## Petition in Support of the Proposed Midvale Plaza Redevelopment

Testimony regarding Midvale Plaza to PC, June 19th, 2006

DATE: June 19, 2006  
TO: Plan Commission, City of Madison  
FROM: Steering Committee  
RE: Westmorland and Midvale Heights Neighborhood Associations  
DENSITY Issues of the Midvale Plaza Proposed Redevelopment Project

RE: 505-555 South Midvale Boulevard  
Midvale Plaza Joint Venture

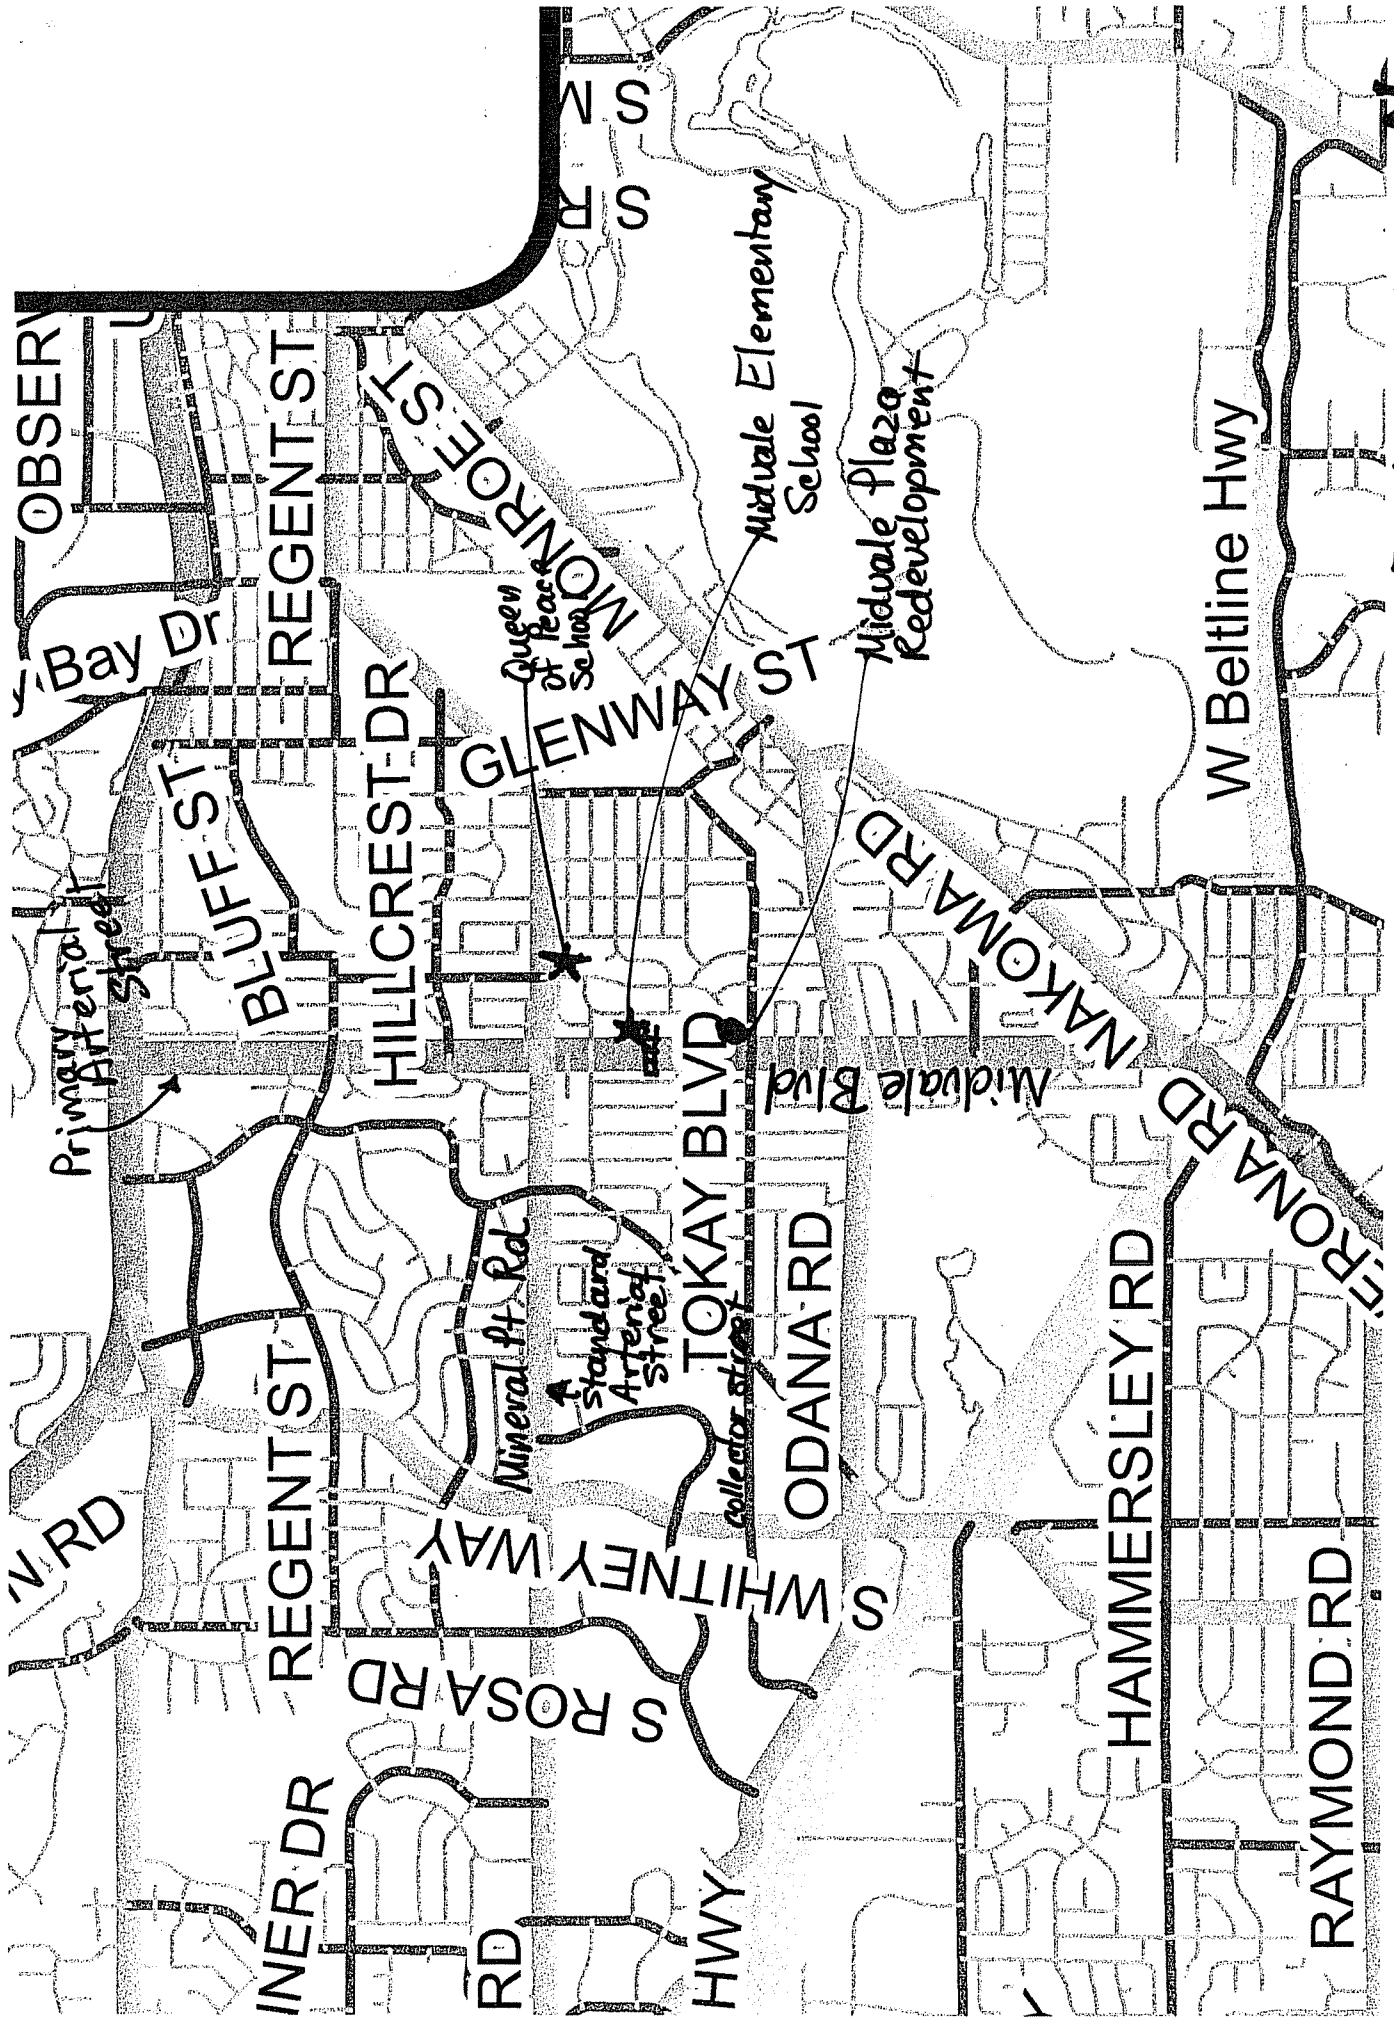
Good Evening, I'm Anna Strenski, and I am on the neighborhood steering committee. We are strongly in favor of redevelopment, urban infill and an expanded library. But, this development, as it is currently laid out, will cause major traffic problems in a Low Density Residential Neighborhood.

This request for a Neighborhood Mixed-use development is predicated on the availability of Midvale and Tokay as major streets – a primary arterial and a collector. Yet, the development places 50%-75% of the traffic burden on Caromar, a small winding residential street with an elementary school a half a block away. Caromar and the surrounding residential streets are **not** designed for the amount of traffic that will be generated by retail traffic, library traffic and these 143 residential units. The residential streets in the neighborhood would support classifying this development for Low Density Residential Use (16 units/acre).

Again the level of density has to fit the capacity of the infrastructure. The density that is proposed is not appropriate for local residential streets. There is a primary arterial street available at this site, which is why the site is rated for **this** scale of development. But, the proposed project makes almost no use of Midvale, and no use of Tokay; instead it puts high-density traffic on low flow streets. We are pleased that the UDC has made approval of this redevelopment contingent on moving the Phase 2 garage to Midvale Blvd.

The Phase 1 entrance/exit garage should also be relocated to Tokay, utilizing a collector street instead of Caromar a residential street. In addition, the surface parking that exits onto Caromar should be forced to turn right, with hardscape control so the traffic is routed to the Tokay/Midvale intersection.

### Parking Level Plan

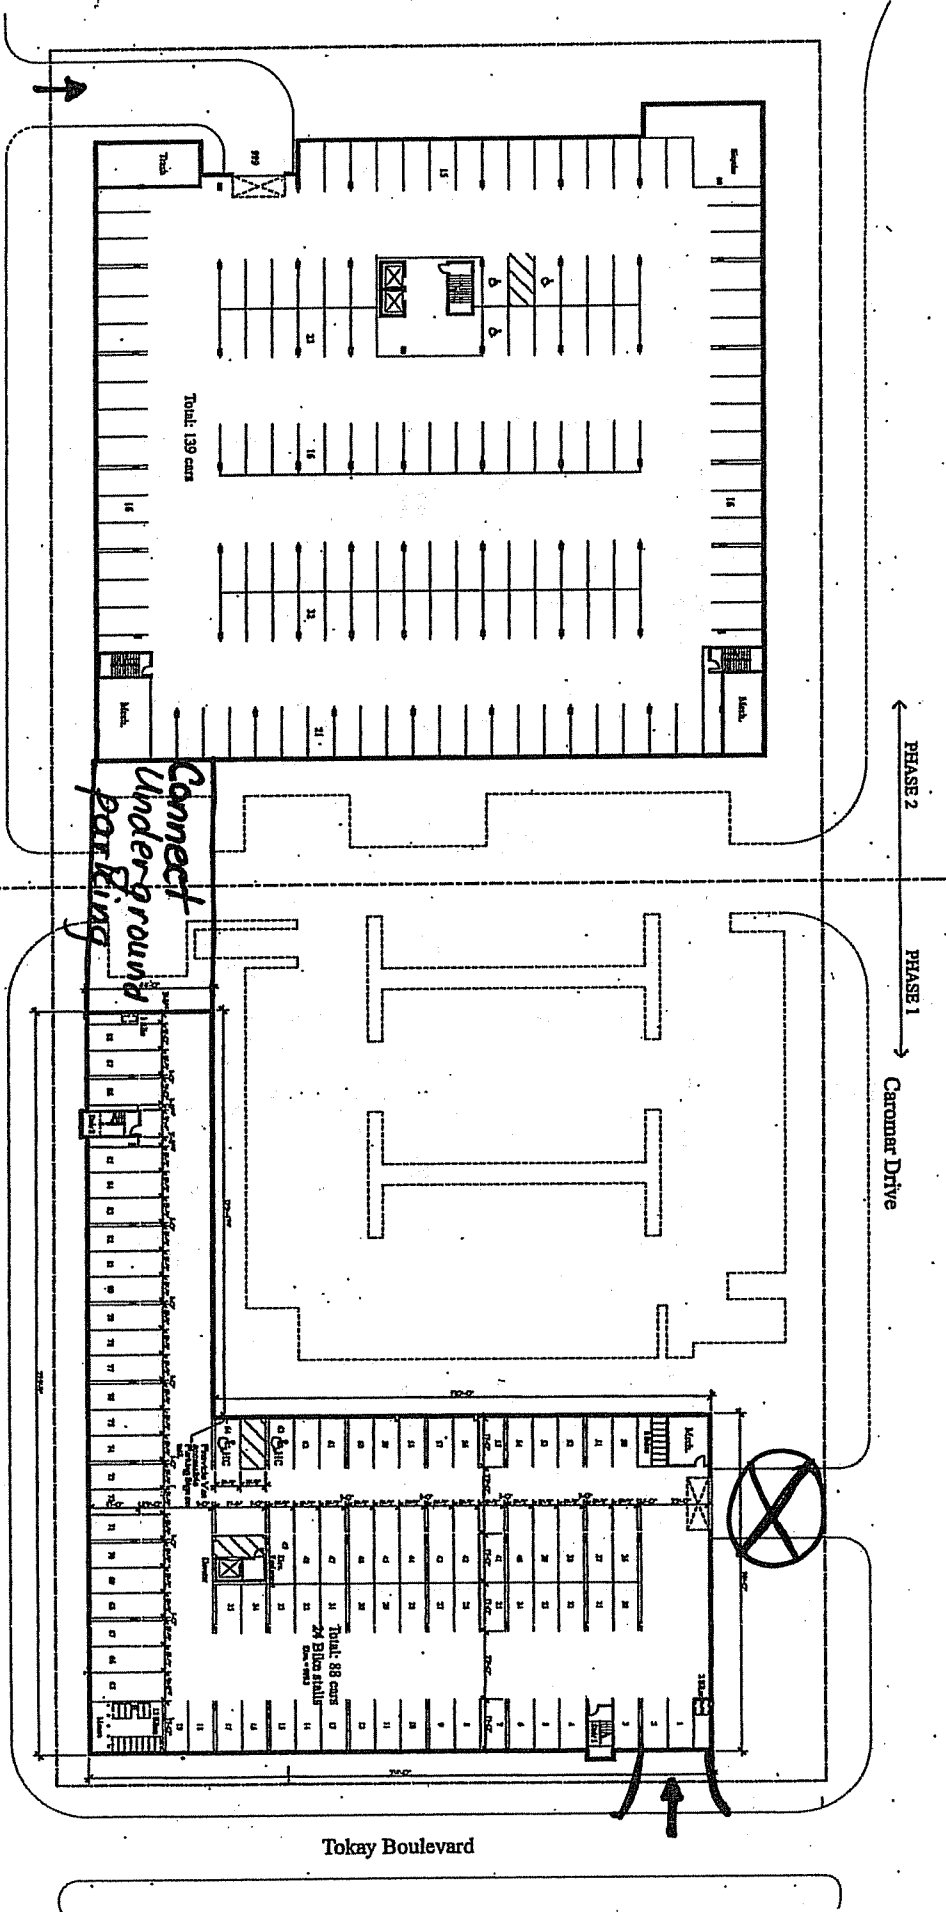
To permit for more flexible and safer traffic flow, the underground parking lots should be connected. This will allow residents to use the Phase 1 garage exit when going South on Midvale and Phase 2 garage exit when going North on Midvale. It also avoids the need for a cut-through of the median on Midvale Blvd.
